INFORMATION LETTER

412-21-90

SUBJECT: TAIL ROTOR BLADES 212-010-750-ALL and 412-016-100-ALL LEAK CHECK.

Figure 1. Areas where cracks can be found.

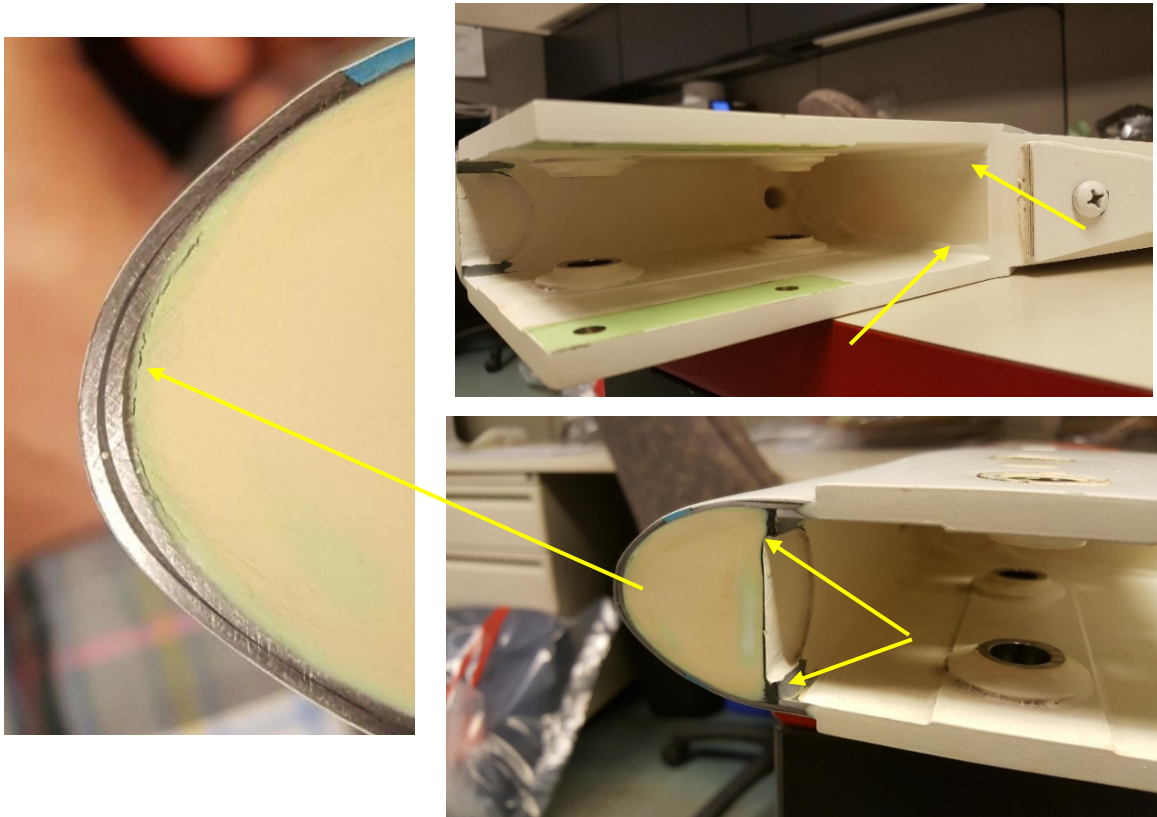
Bell has received reports of tail rotor blades failing the leak check required per the 412 Maintenance Manual (MM) when suspected cracks are found in the blade root end cuff area. In some cases, due to misinterpretation of the results, blades rejected due to indications of air bubbles were in fact serviceable. Figure 1 below shows some areas where cracks can be found. The cracks found in the root end cuff area are usually limited to the adhesive squeeze-out produced during manufacturing and are not necessarily an indication of a bonded joint failure.

The crack repair procedure found in the MM and the 412 Component Repair and Overhaul Manual (CR&O), has also been changed. The adhesives (C-363) and (C-313) listed in the MM and the CR&O to repair cracks in the root end area are replaced by sealant (C-308). The flexibility of sealant (C-308) will allow the fine cracks to remain sealed and prevent further cracking with time in service.

“Check for air leaks which will be indicated by a steady stream of fine air bubbles originating from a single point at a rate exceeding one every five seconds. Occasional air bubbles is not criteria for rejection. If in doubt, contact Product Support Engineering.”
